MISTY COVE LANE

CERTIFICATE OF COMPLETION/OPERATION PERMIT

Subject: LOt 193 sec. 6 Mecklenburg County Misty Cove Lane
File # : 9248A
Parcel : 001-382-15

RE: Property located at 22016 Misty Cove Lane
FILE: 7248A
PARCEL: 001-382-15

FILE # 1248-A

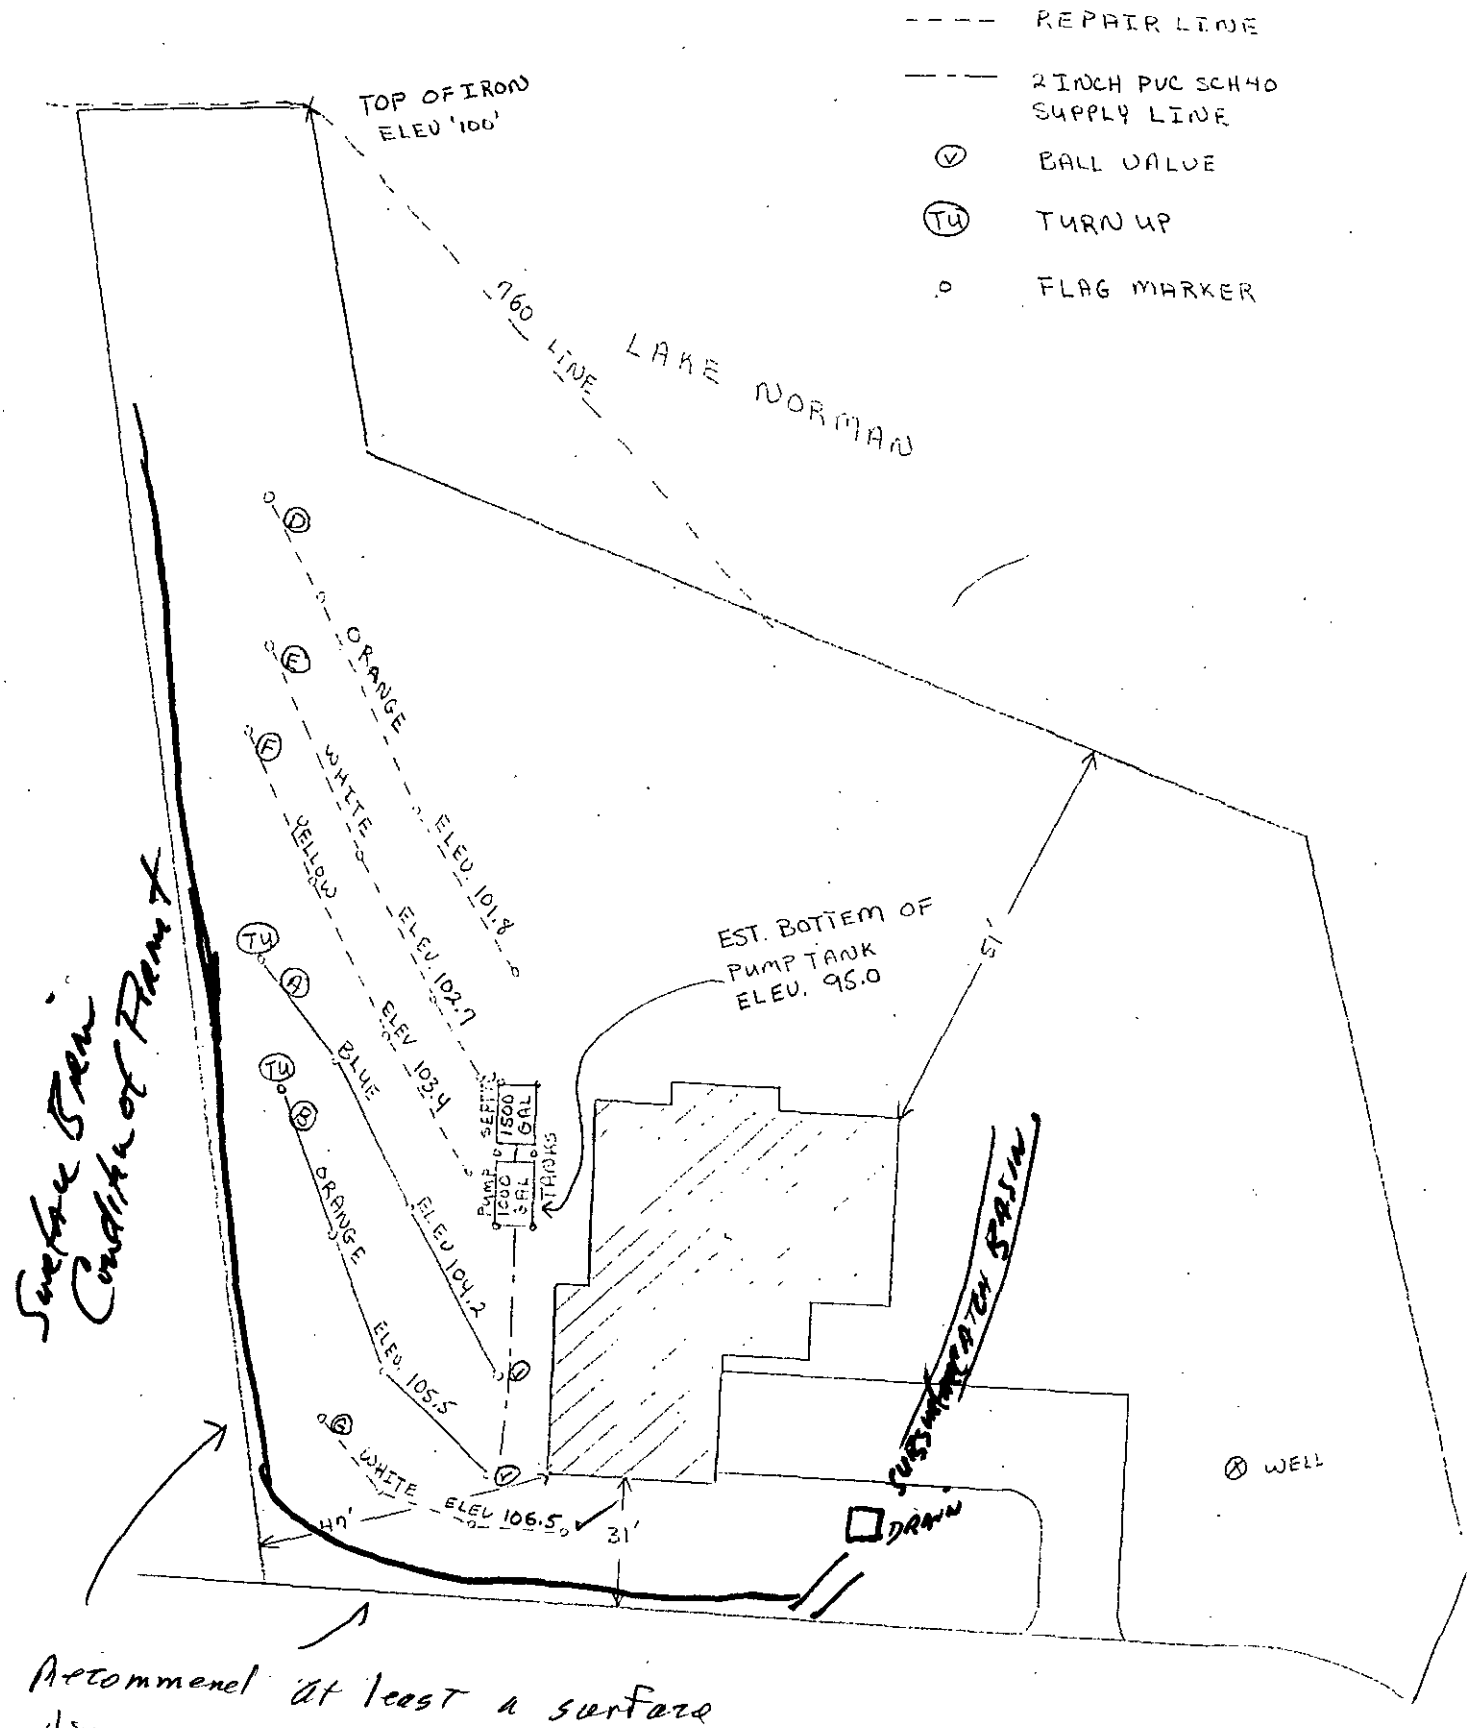
Recommend at least a surface diversion Along Misty Cove lane & left property line W.A. Martin - Soil Scientist

Approved as Designed

MECKLENBURG COUNTY HEALTH DEPARTMENT
SITE EVALUATION REPORT
SERIAL NUMBER 17110

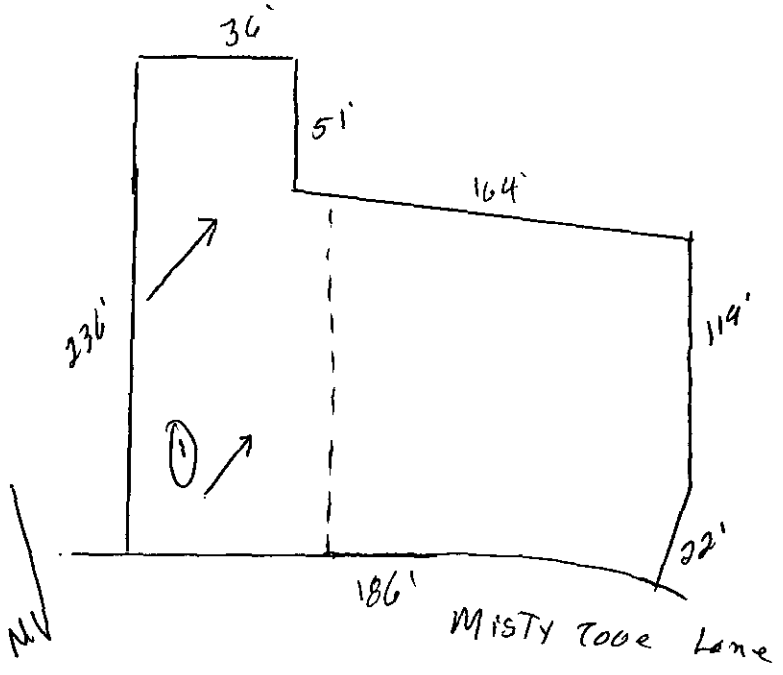
Comments: Would recommend surface diversions along Misty Cove Lane and left property line, possibly subsurface interceptors
